Chapter 5 Suggestions

Thank you for your continued great work. Below are some suggestions for finishing up Chapter 5 of the Comprehensive Plan.

R1 on W. Stadium

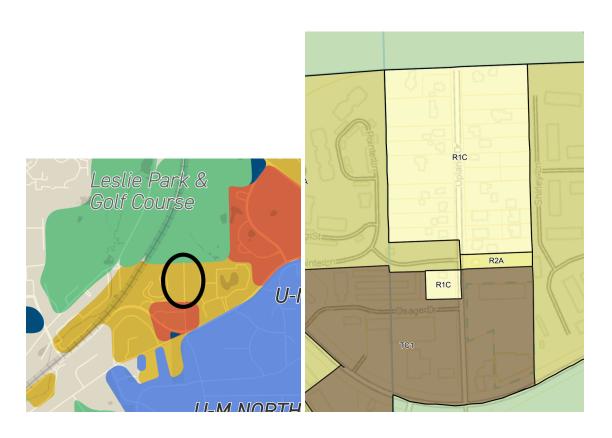
I don't think these inclusions will end up being very important, because the buffering rules for Transition will limit the heights in these areas to a level similar to the immediately adjacent residential districts.

The main effect of marking these areas Transition would be to allow a wider variety of businesses than those allowed in the Residential category. I see this flexibility as a good thing, so long as the city enforces performance and nuisance standards, but I don't expect many developers will be eager to buy expensive single-family houses and tear them down to build light-industrial facilities. I think the end result will be similar if the city marks these R1 parcels as Residential.

However, these inclusions are going to be very controversial, and I expect many homeowners who see that their home is in or near a Transition district are feeling singled out and angry. If you find that putting these parcels in Transition is jeopardizing the plan politically, I don't think you should insist on keeping them in Transition.
